RADIO RECEIVERS R-274/FRR, R-274A/FRR, R-274C/FRR, AND R-274D/FRR

CHANGES No. 2

HEADQUARTERS,
DEPARTMENT OF THE ARMY
WASHINGTON 25, D.C., 8 March 1962

CHANGES }
No. 1 }DEPARTMENT OF THE ARMY
WASHINGTON 25, D. C., 12 May 1954

Figure 2.1. (Added) Radio receiver R-274D/FRR, rear view.

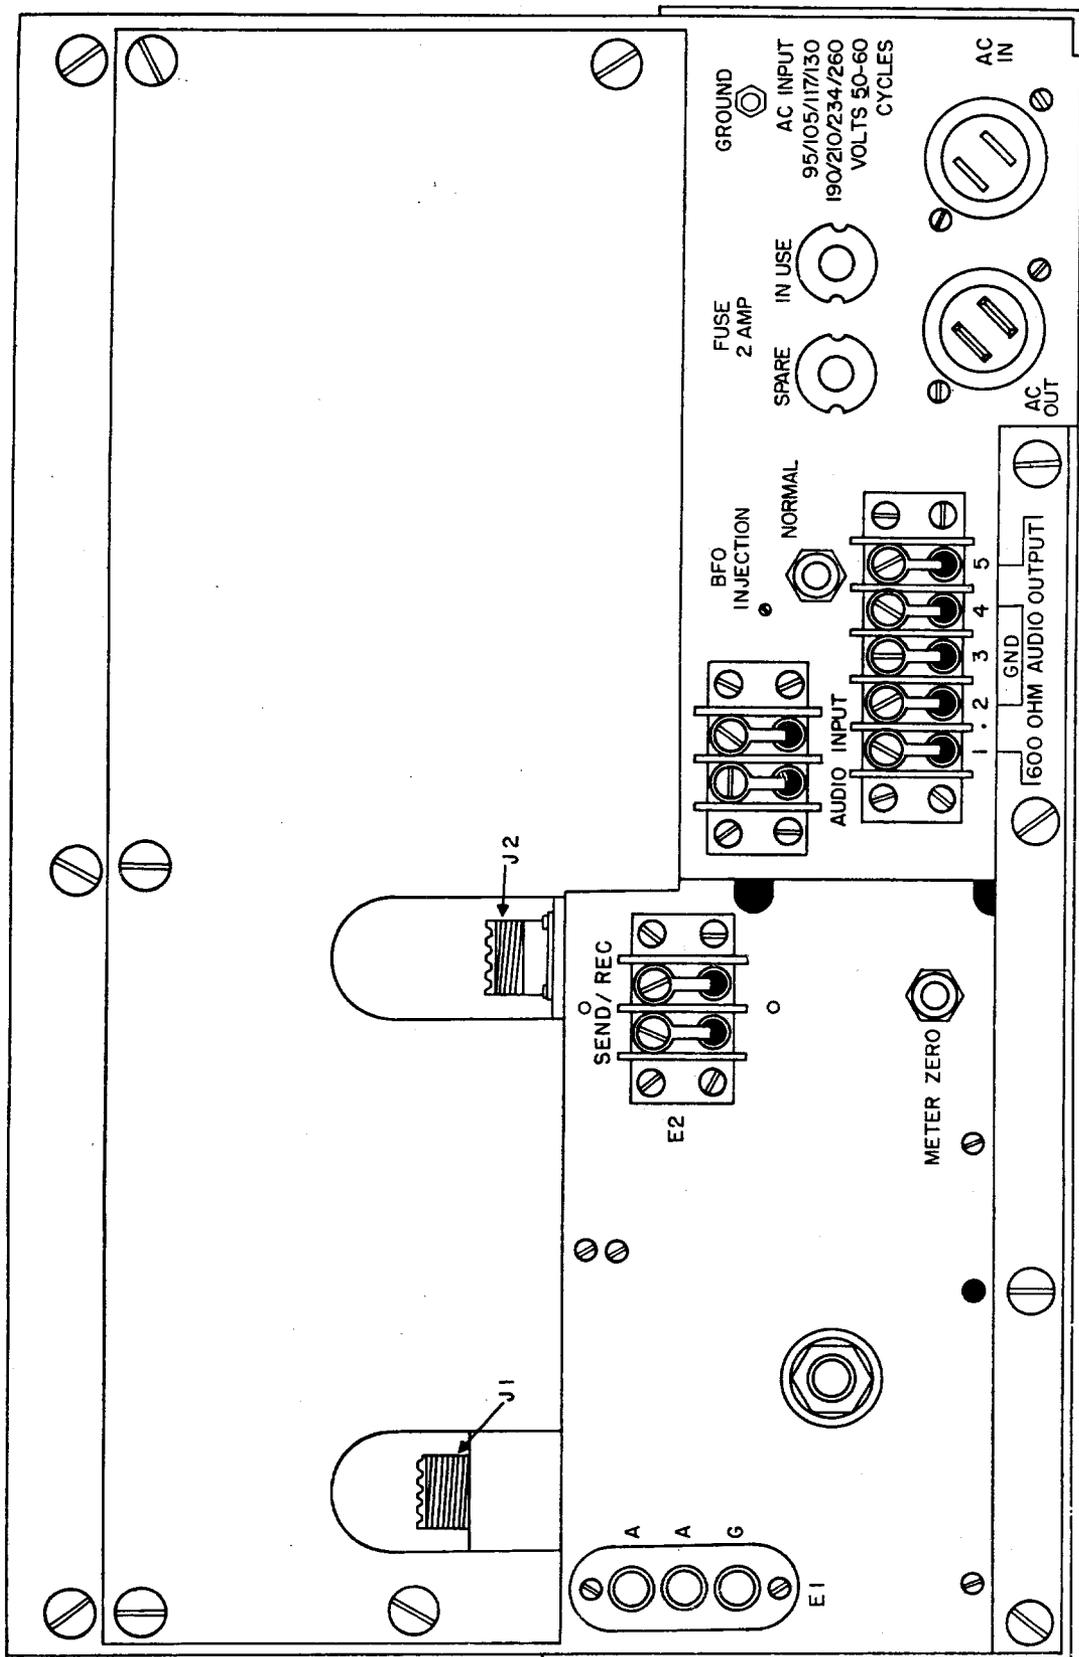
The design of Radio Receiver R-274D/FRR includes an antenna disabling relay which was not used in the unlettered model. This relay (K2) shorts the receiver to ground, thereby preventing damage to the receiver antenna coils during transmission. The relay is mounted under the chassis near the rear of the rf turret (fig. 32.1). On Order No. 3464-Phila-52, serial numbers 674 through 1266, a neon lamp (E53) has been added across the antenna contacts of the antenna disabling relay K2 (fig. 14.1). In addition to this modification, other minor changes have been made. They are as follows:

d. The lettering on the rear panel is revised (fig. 2.1).

Figure 14.1. (Added) Radio receiver R-274D/FRR, antenna disabling relay schematic.

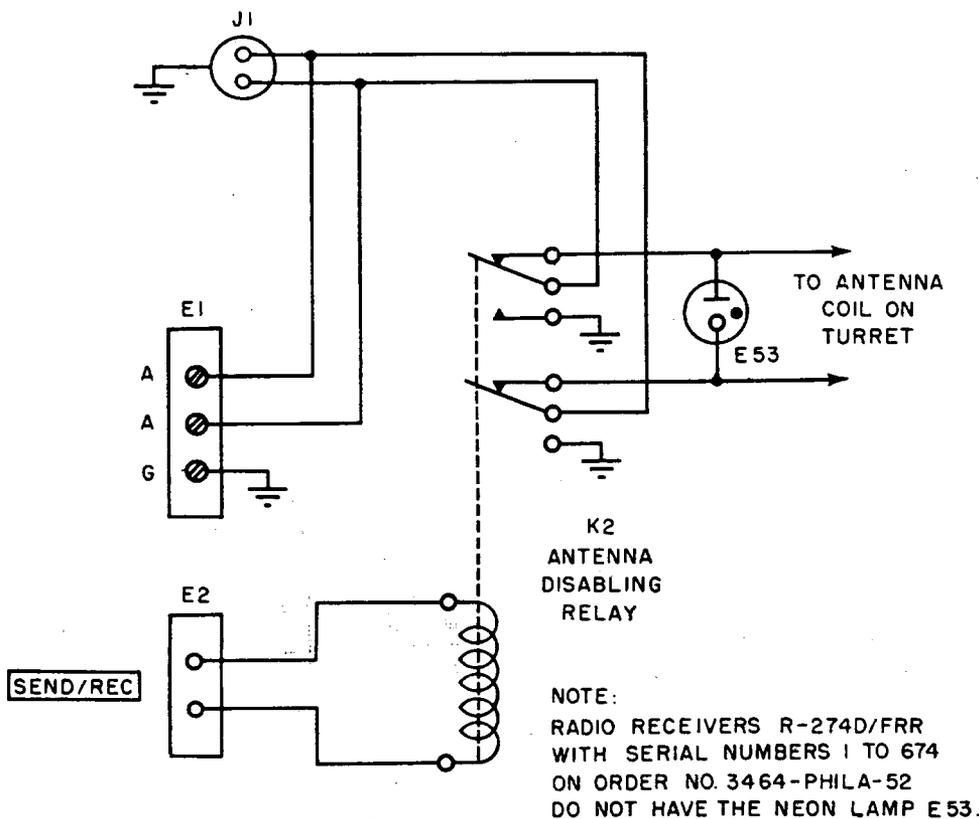
b. In the partial * * * terminal A of E1. In Radio Receiver R-274D/FRR the signal from

antenna connectors E1 and J1 must pass through the contacts of relay K2 before reaching the antenna coil. The relay is normally in the receive (REC) position with the antenna connected to the antenna coil. The relay is actuated to the SEND position by application of 12 volts dc at the termi-

nals of E2 from an external source. In this position, the antenna input leads are both grounded to the chassis through a set of relay contacts and the antenna coil is an open circuit. This prevents the transmitter rf radiation from causing damage to the antenna coil. A neon lamp is connected across the antenna disabling relay contacts on serial numbers 674 through 1266 of Order No. 3464-Phila-52. This lamp prevents damage to the antenna coil due to the high voltage static surges. Figure 14.1 is a schematic diagram of the relay circuit. Capacitor C22 (ANT ADJ) * * * lower frequency band.

Figure 32.1. (Added) Radio receiver R-274D/FRR, rf chassis bottom view.

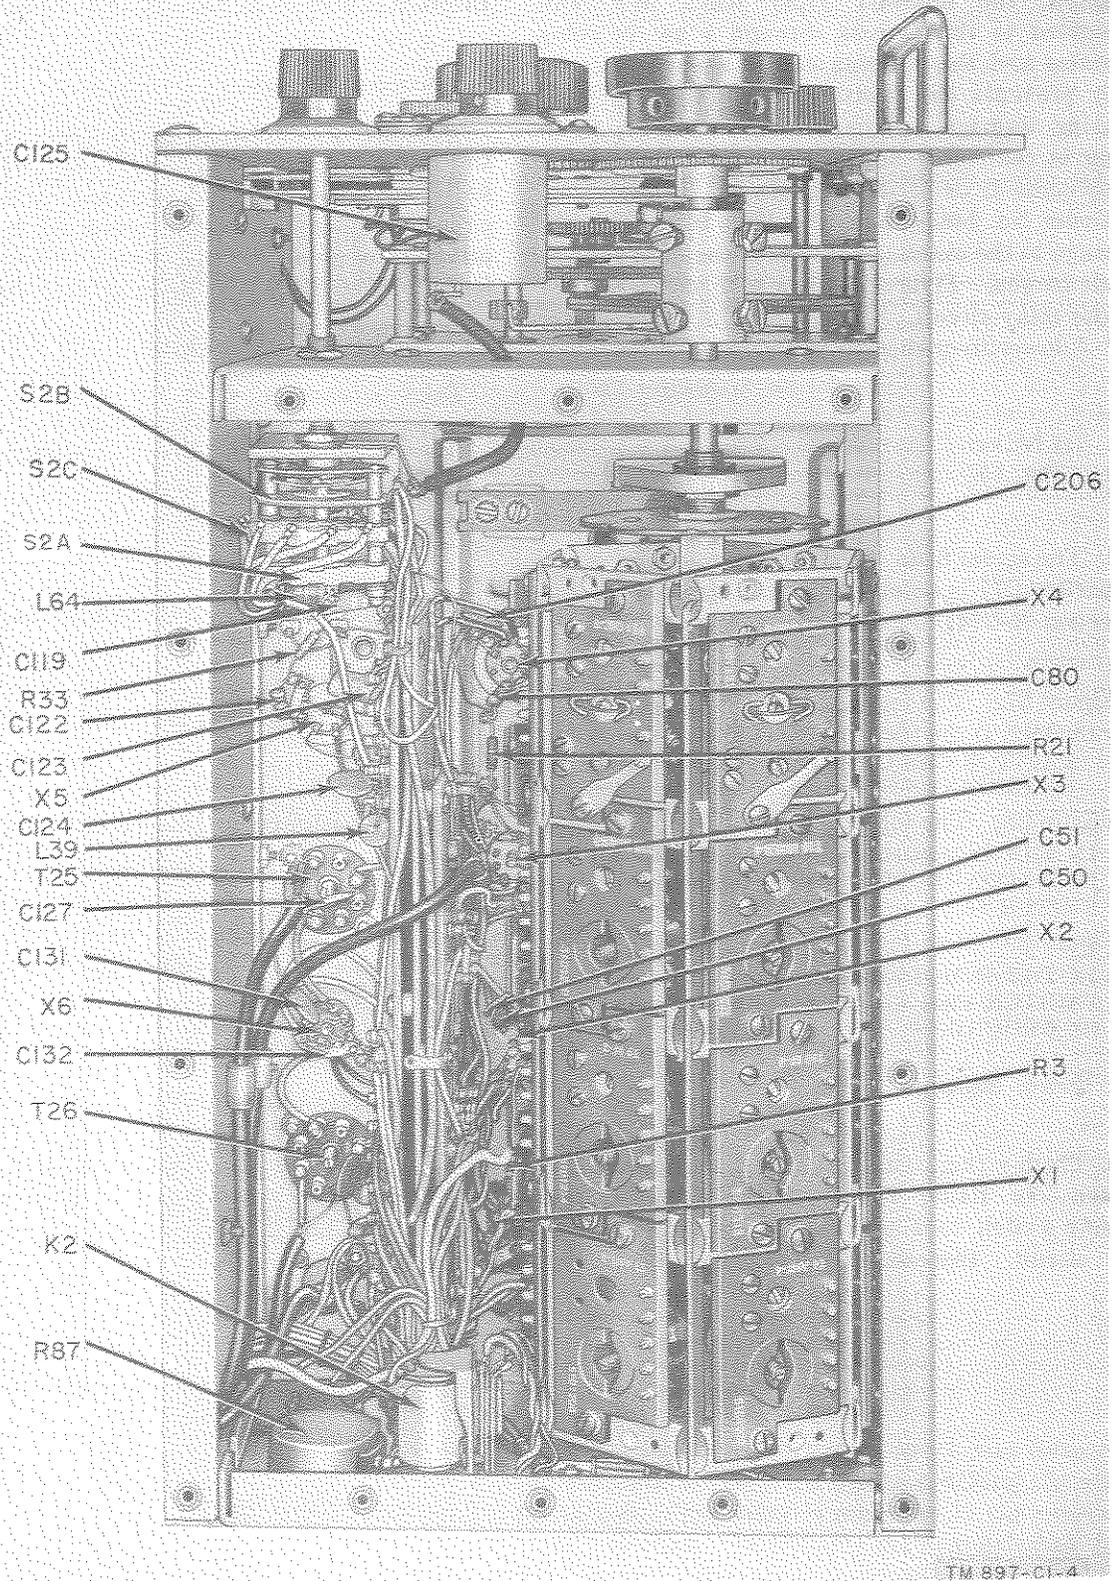
e. R-f Turret (figs. 32 and 32.1). The removal of * * * chassis as follows:
